September 7, 2023

Re: Comment Response Letter:
Rod and Wire Mill 2022 IM Report
Area A: Parcel A3
Tradepoint Atlantic
Sparrows Point, MD 21219

ATTACHMENT 1

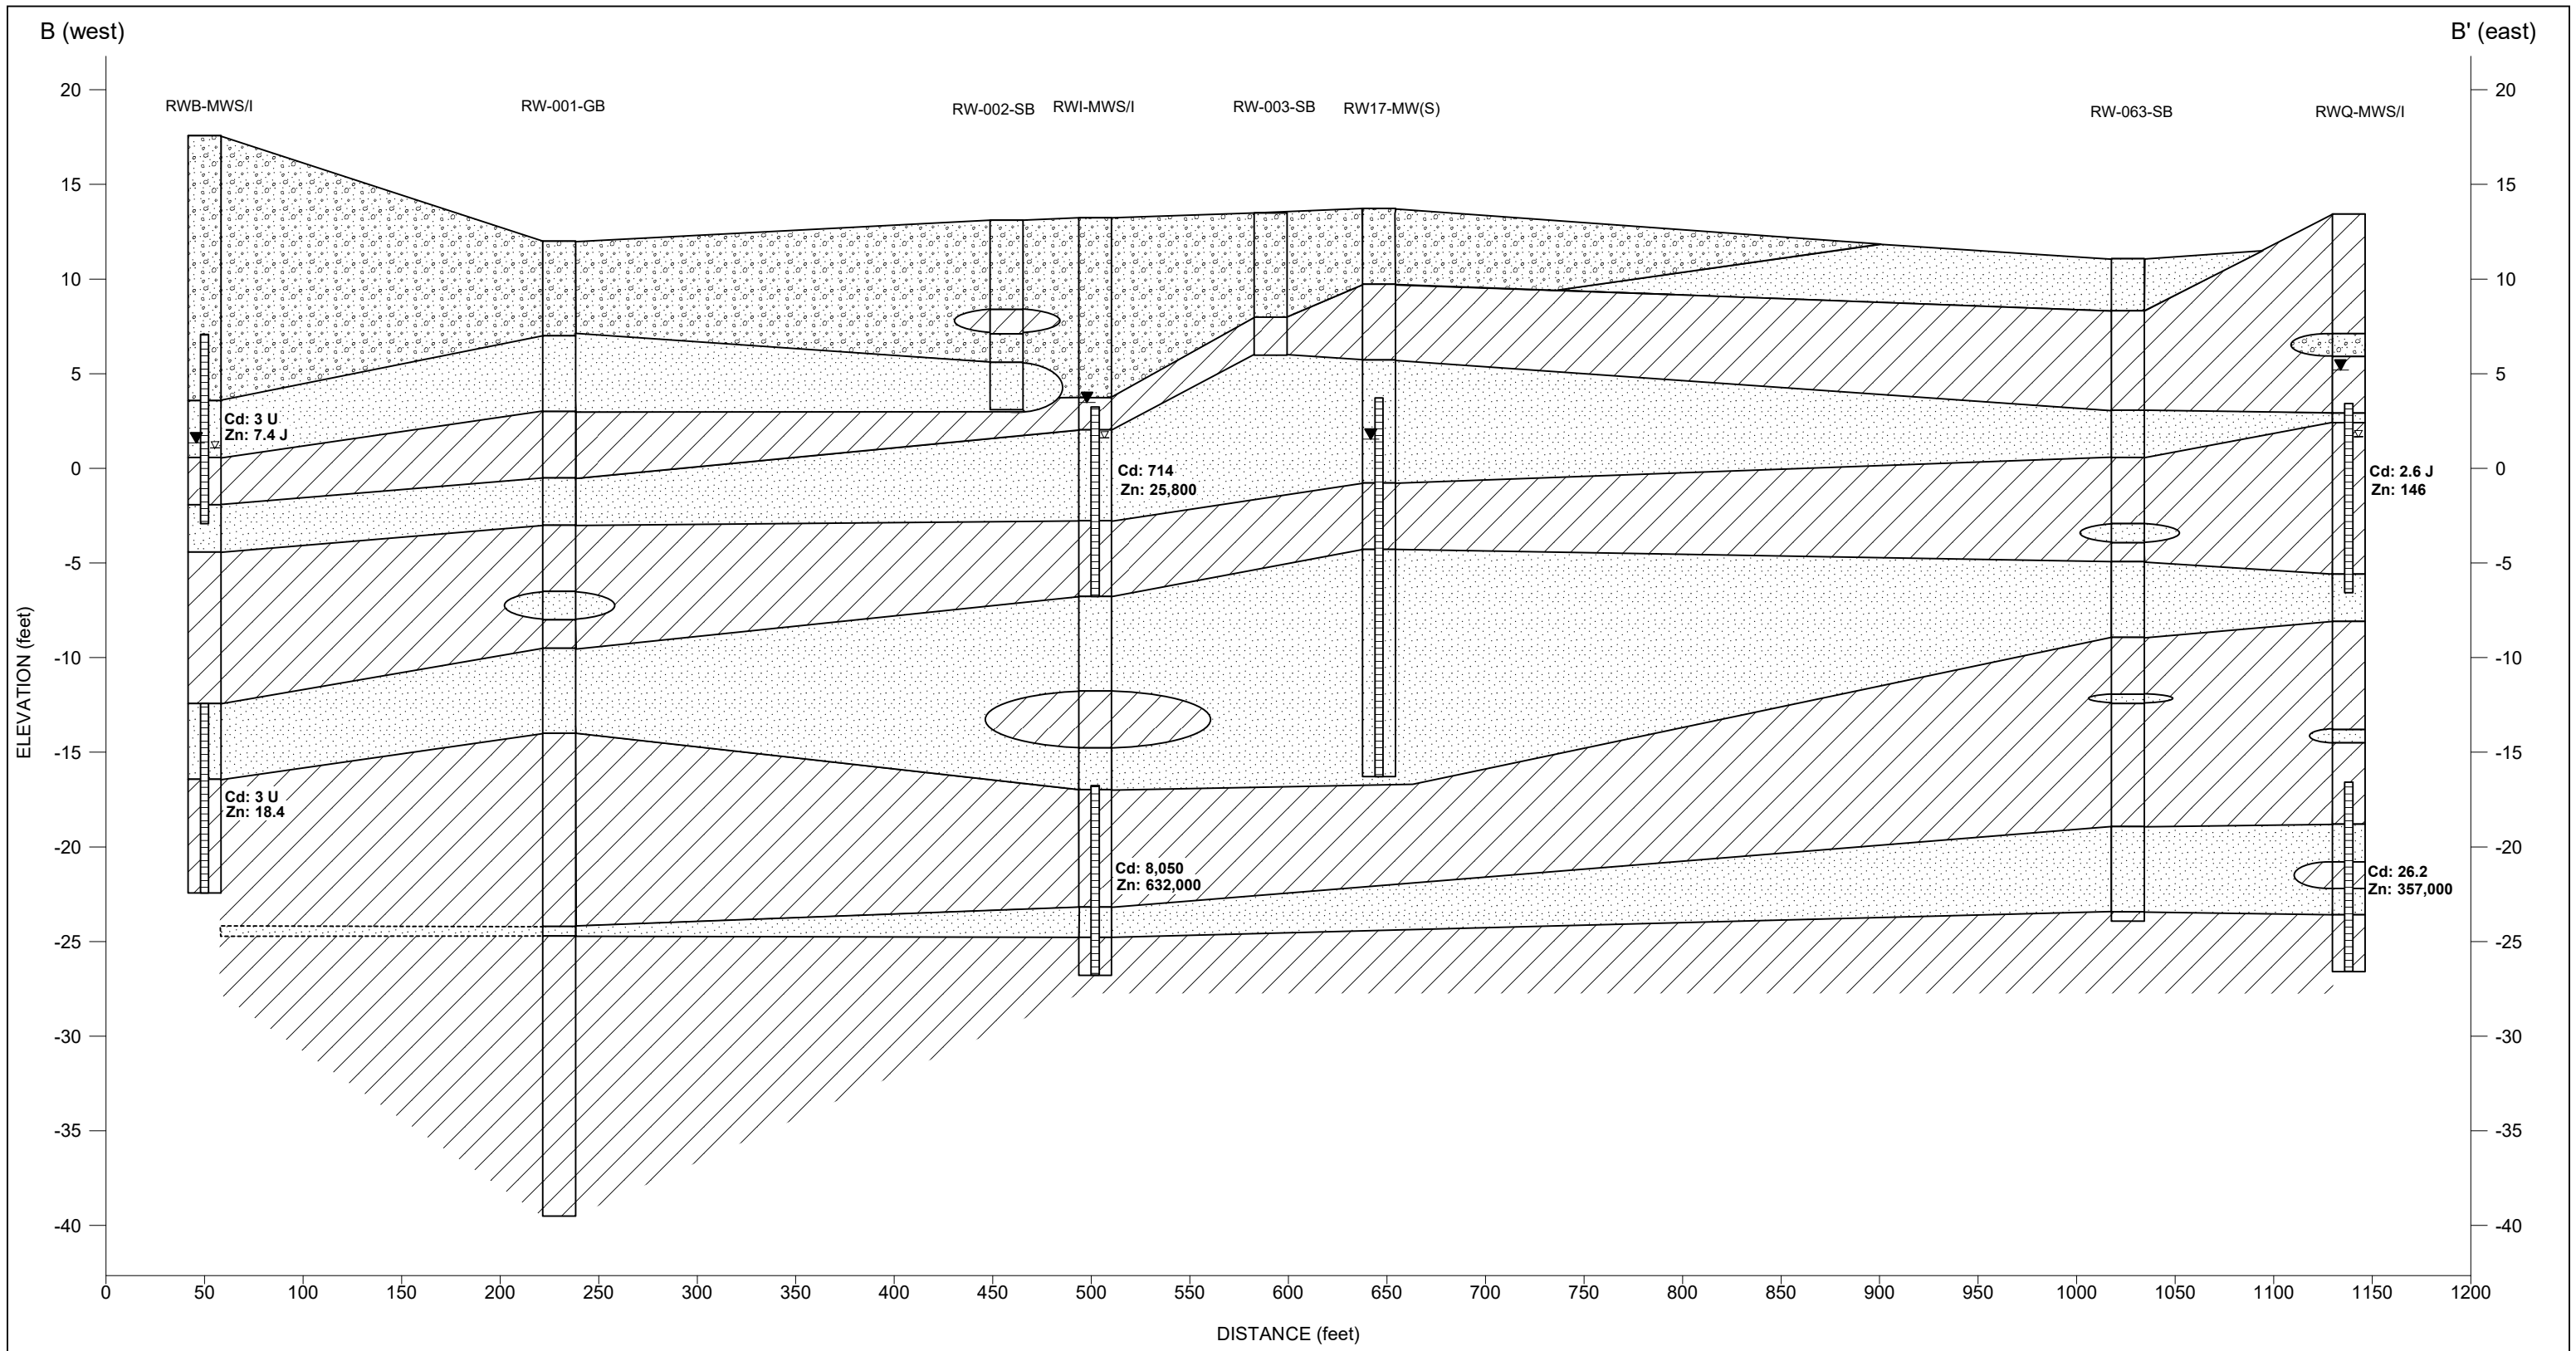
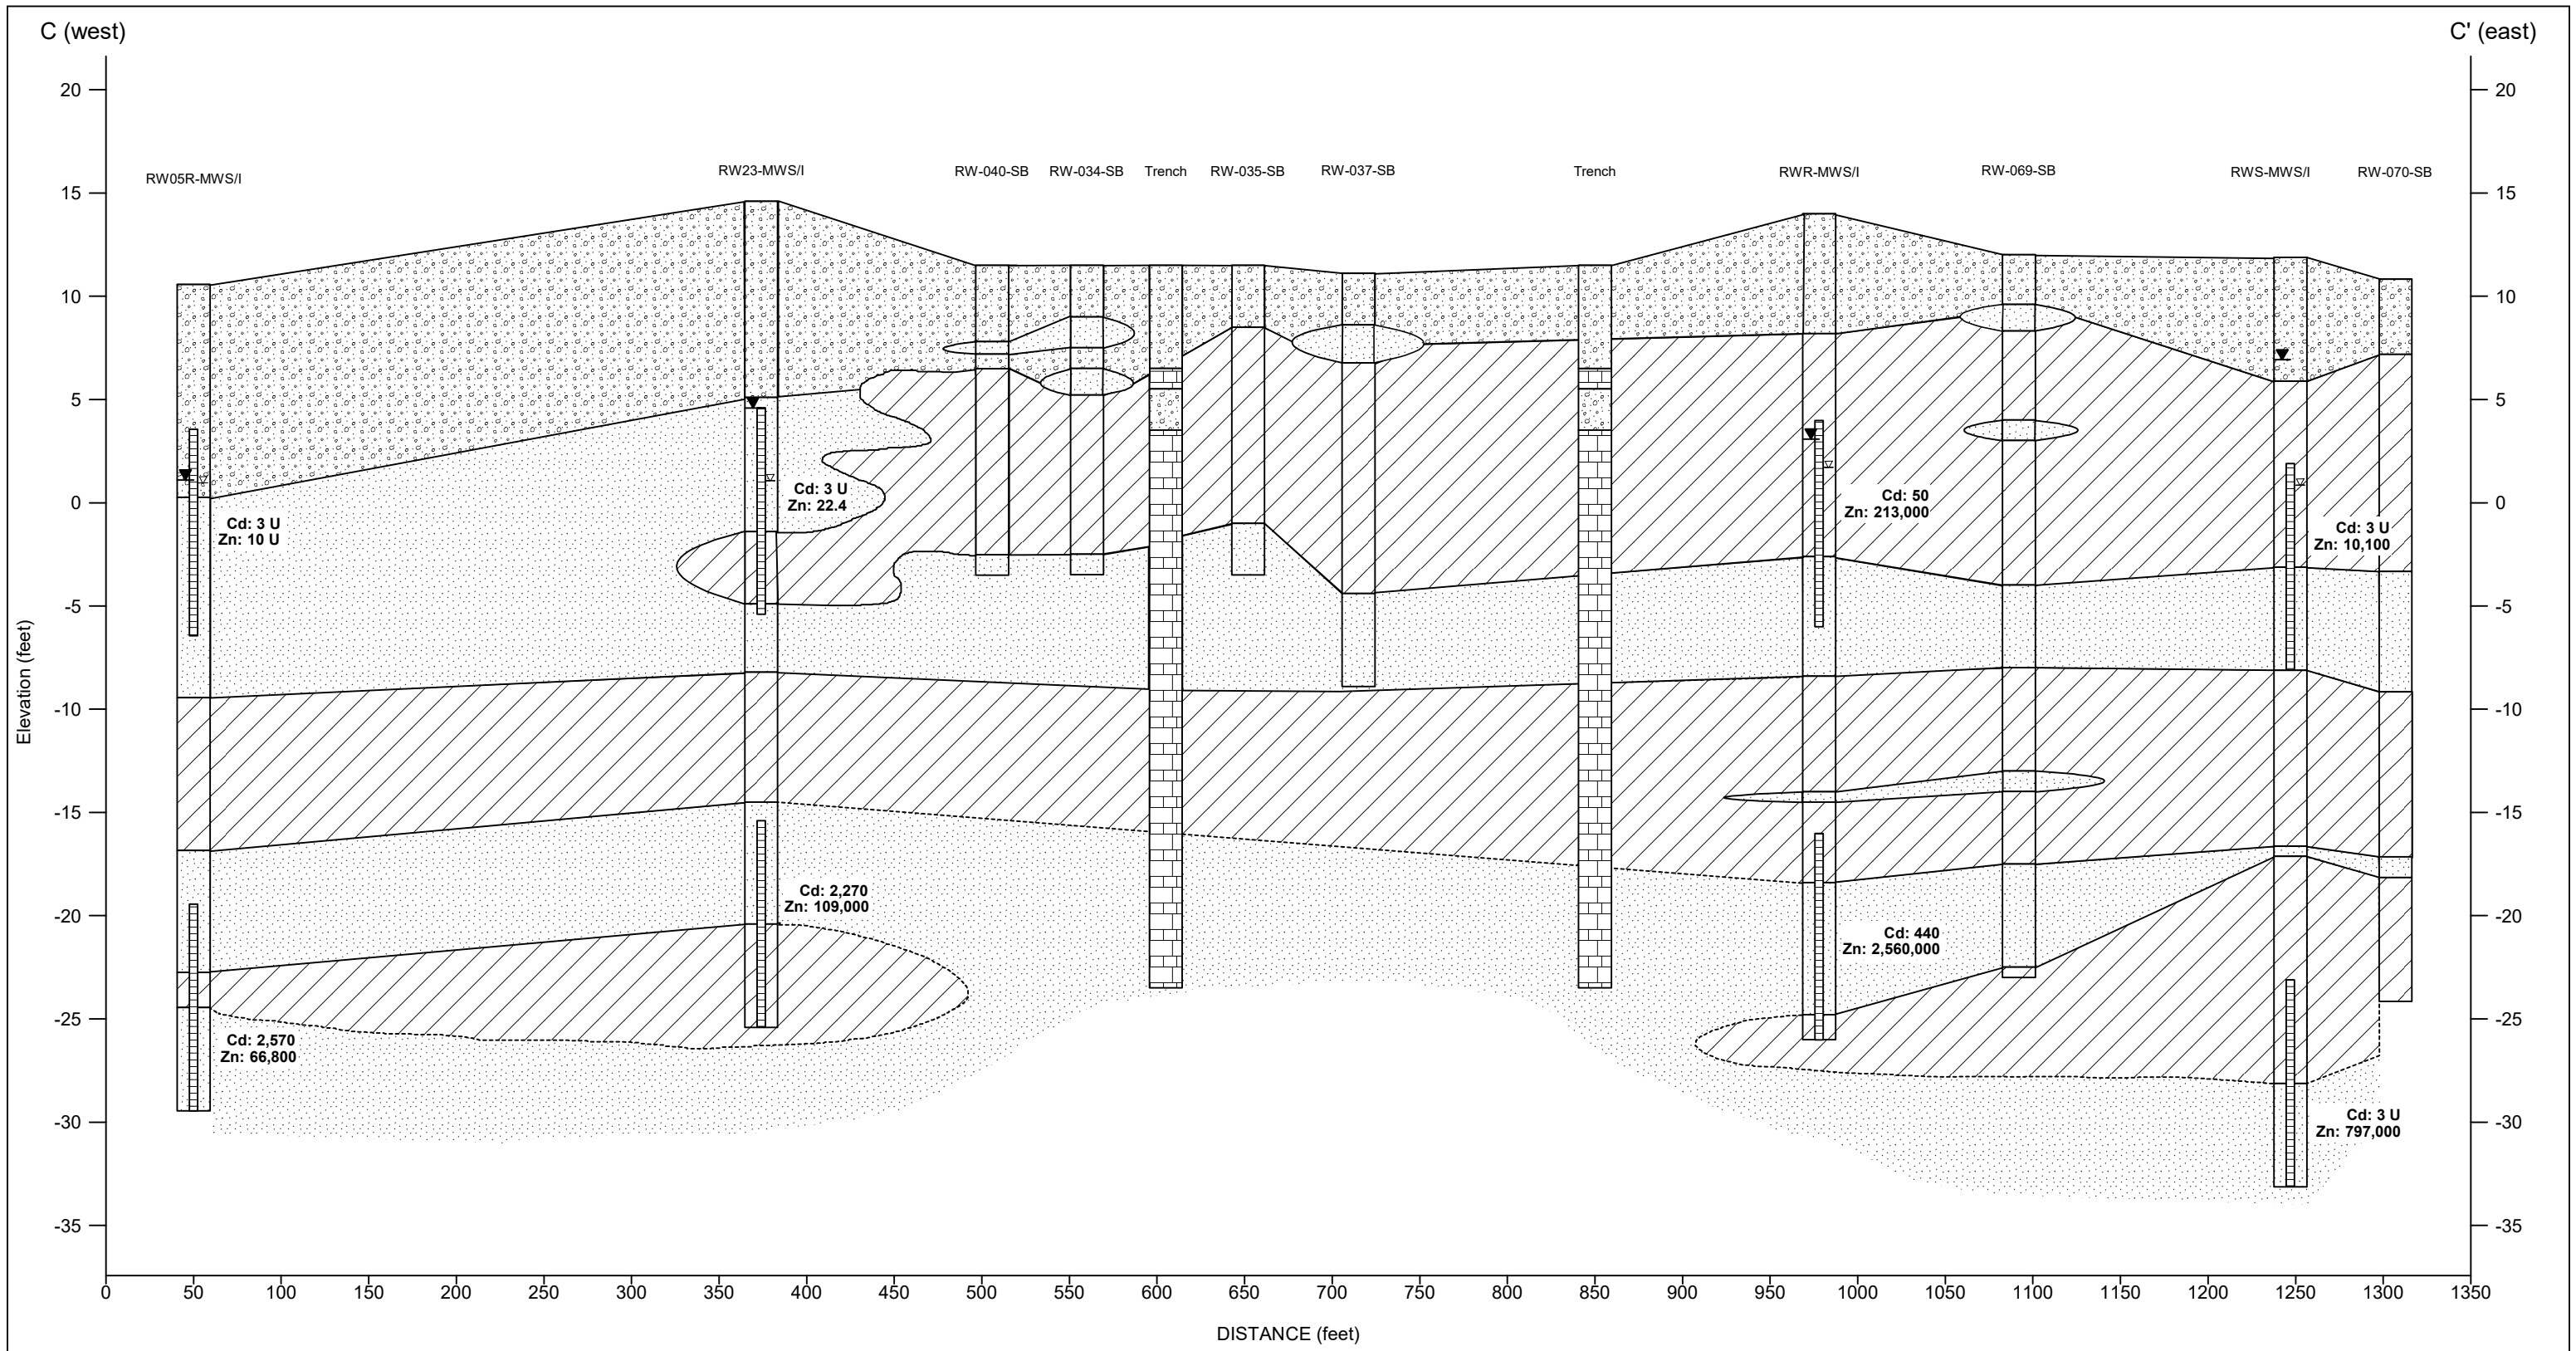
- *Additionally, Section 3.1 stated that groundwater flow in the intermediate zone is approximately 5 ft/yr. If RWK-MWI and RWL-MWI are located ~10 and 20 feet, respectively*

from the trench, and the trenches were installed in early 2017, it stands to reason that groundwater treated in the trench has already reached these two monitoring wells. Please provide a brief discussion on the stratigraphic sequence corresponding to the shallow and intermediate groundwater zones.

Response: As part of the RWM Supplemental Investigation Report (Revision 1, April 8, 2020), there is a detailed discussion of site geology, site hydrogeology, groundwater flow, and hydraulic gradients. Cross sections were also included in this previous submittal. All cross sections are included as Attachment 1 to this CRL for reference.
